ADDENDUM NUMBER 2 – JULY 22, 2024

AUGUSTA REGIONAL LANDFILL – LFGCCS EXPANSION

SOLID WASTE PERMIT NO. 21 AND NO. 585

Prospective Bidders are hereby advised of the following revisions to the Bid Documents for the subject Project:

8 SILT FENCE BREAK DETAIL (SFB)
 NOT TO SCALE

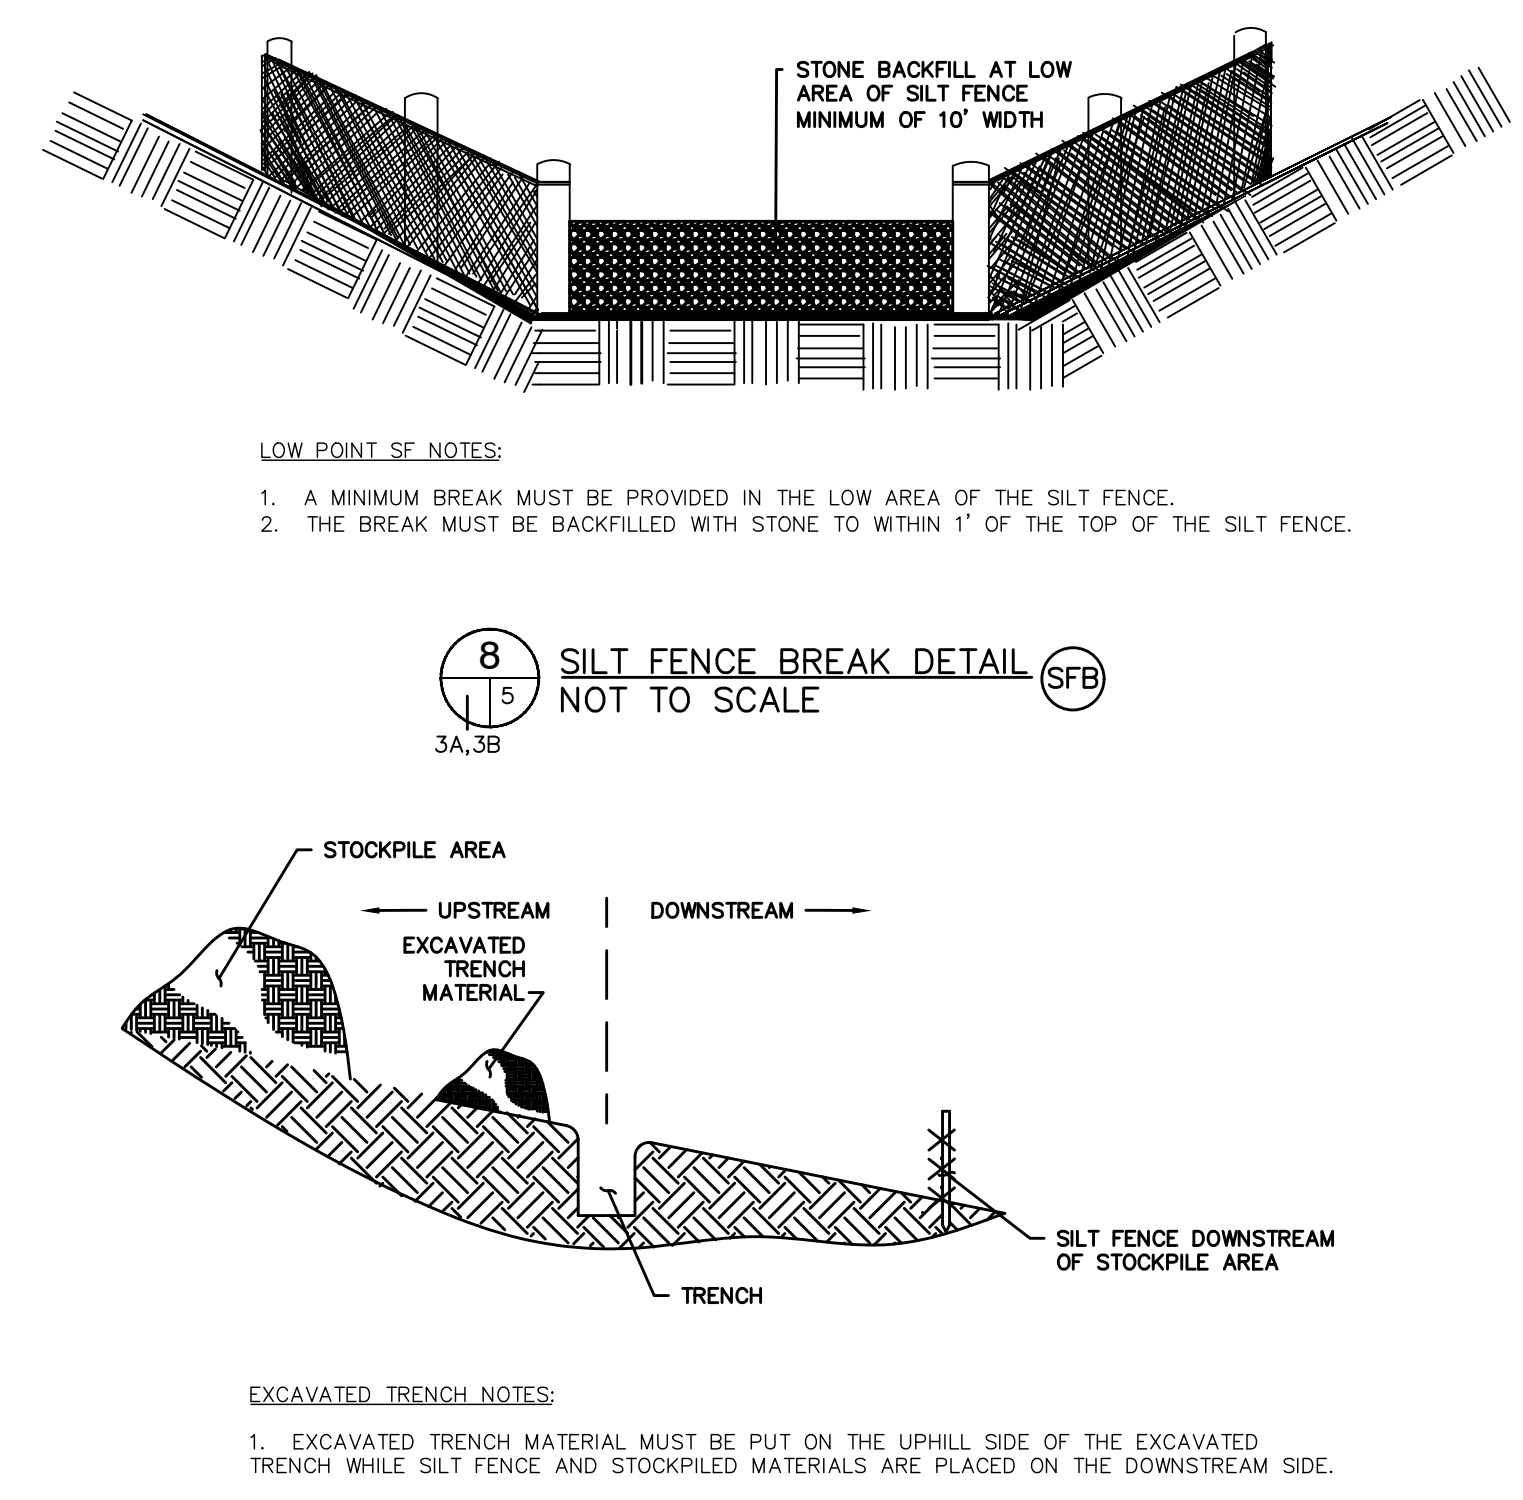
Question 19: In some cases the gap between sections of silt fence where silt fence breaks are designated on Sheet No. 3A and Sheet No. 3B is greater than the minimum 10-foot length shown in Detail 8 on Sheet No. 5. How long should the silt fence breaks be at these locations?

Answer: The silt fence break may be limited to 10 feet as long as the silt fence break is aligned with the low point on the silt fence to allow stormwater to effectively discharge. The contractor should provide silt fence to supplement the 10-foot width of the silt fence break, between the end of the silt fence as shown in plan view and the silt fence break. There should not be a gap between the silt fence and silt fence break. Additional silt fence utilized between the limits of the silt fence in plan view and the silt fence break shall be at no additional cost to the owner.

| SHEET TITLE | SWP #21 PROPOSED GCCS DESIGN LAYOUT |

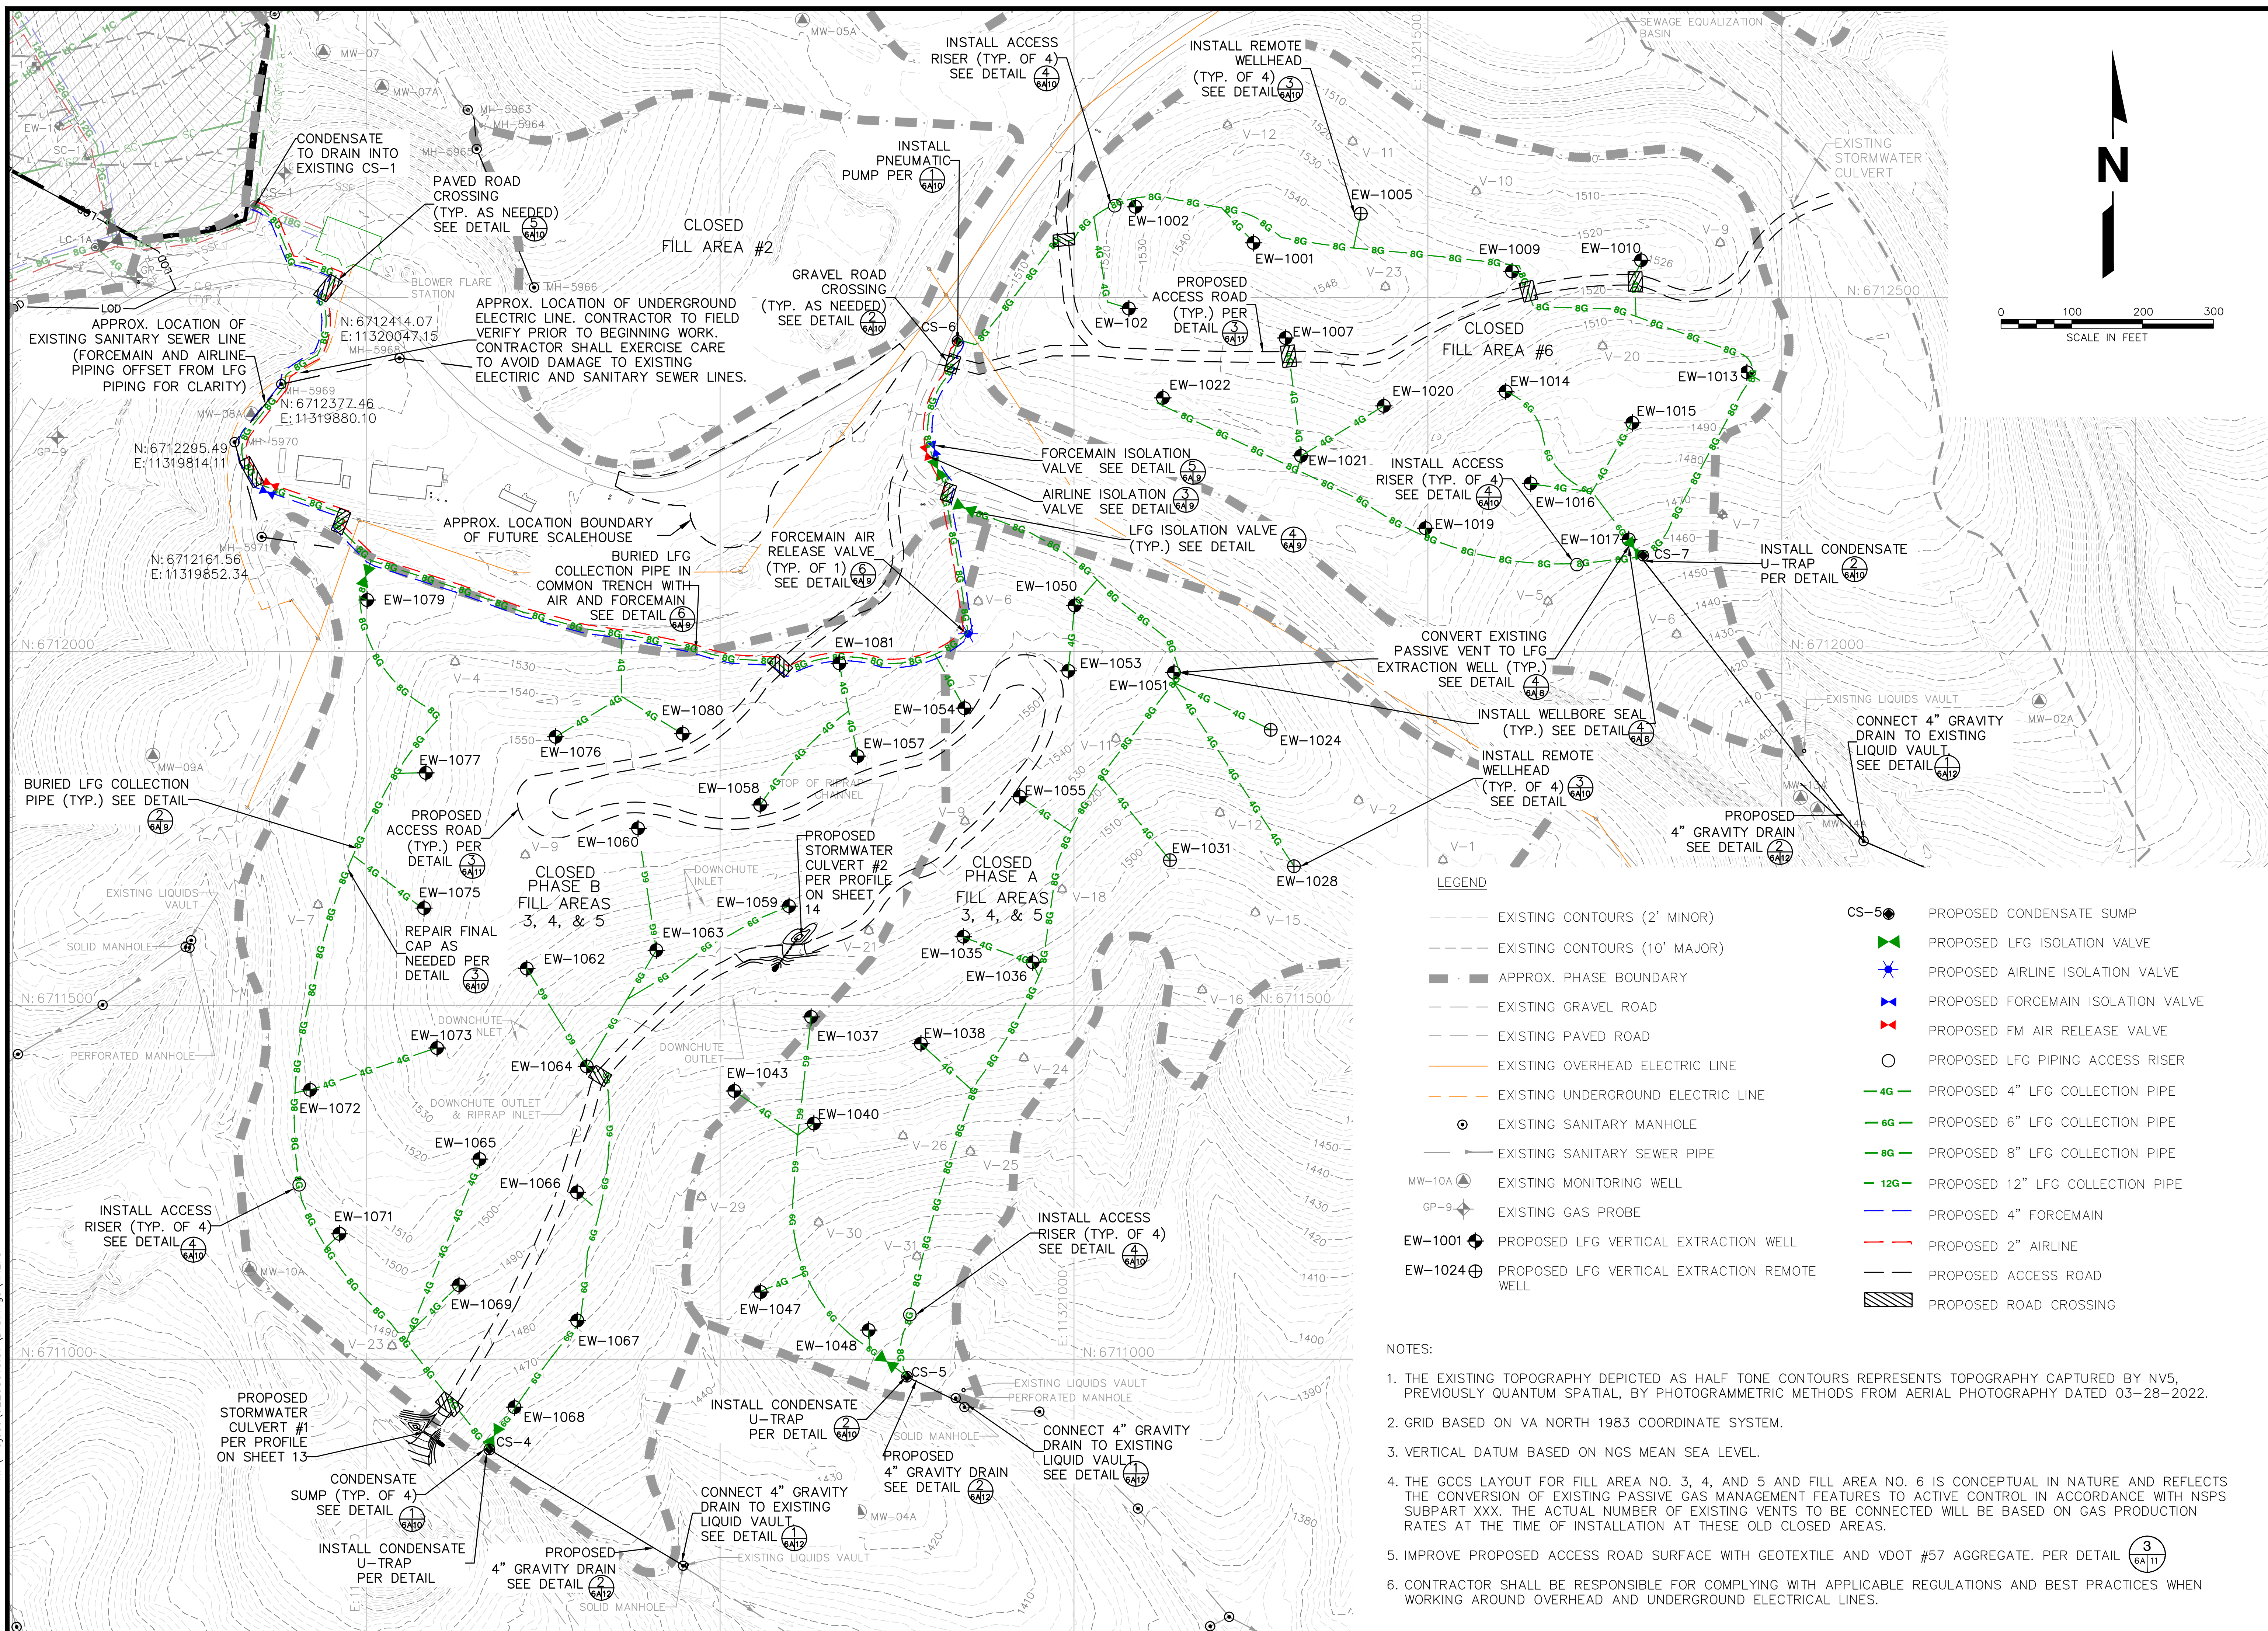
- Changes to the proposed silt fence installation have been made to Sheet No. 3A.
 - A callout for the installation of landfill gas collection piping in a common trench with airline and liquids forcemain has been added to Sheet No. 6A.

Question 7: Detail 1 on Sheet No. 9 references Sheet No. 6A, but there was not a call-out for Detail 1 Sheet No. 9 on Sheet No. 6A. What is this detail referring to?

Answer: Detail 1 on Sheet No. 9 is the typical detail for the installation of Landfill Gas Collection piping in a common trench with airline and liquids forcemain. The detail should be used when landfill gas collection piping, airline, and liquids forcemain are shown running parallel to one another (i.e. in a common trench). Bidders should be familiar with this type of installation. A callout has been added to Sheet 6A for clarity.
